Project	IEEE 802.16 Broadband Wireless Access Working Group http://ieee802.org/16
Title	For comment#1012: Adjusting figure 17c – GPCS Layering Model
Date Submitted	2006-05-10
Source(s)	Achim Brandt, Achim.Brandt@siemens.com Maximilian Riegel
	Siemens AG
Re:	Showing figure 17c explicitly, with the changes proposed in Comment #1012
Abstract	Adjusting figure 17c by removing the boxes representing the interfaces for the particular protocols labeled 'IPv4 over 802.16', 'IPv6 over 802.16', 'IEEE802.3/Ethernet over 802.16', '802.1Q/VLAN over 802.16' Rename 'Multiple protocols over 802.16' into 'Multiple protocols encapsulation'
Purpose	For approval as part of Comment #1012
Notice	This document has been prepared to assist IEEE 802.16. It is offered as a basis for discussion and is not binding on the contributing individual(s) or organization(s). The material in this document is subject to change in form and content after further study. The contributor(s) reserve(s) the right to add, amend or withdraw material contained herein.

Protocol structure with the Generic Packet Convergence Sublayer (GPCS)

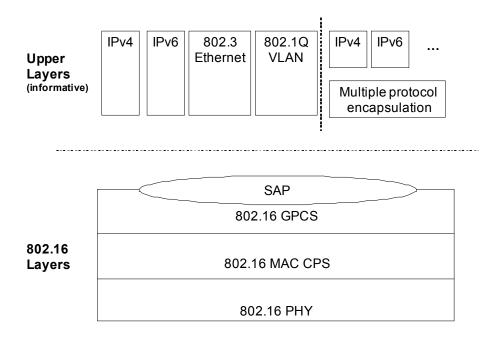
- Adjust figure by removing the boxes representing the interfaces for the particular protocols labeled 'IPv4 over 802.16', 'IPv6 over 802.16', 'IEEE802.3/Ethernet over 802.16', '802.1Q/VLAN over 802.16'.
- Rename 'Multiple protocols over 802.16' into 'Multiple protocols encapsulation'

This contribution shows how Figure 17c will look like once this remedy is applied.

Corresponding Change to figure 17c in 802.16g/D2, page 10
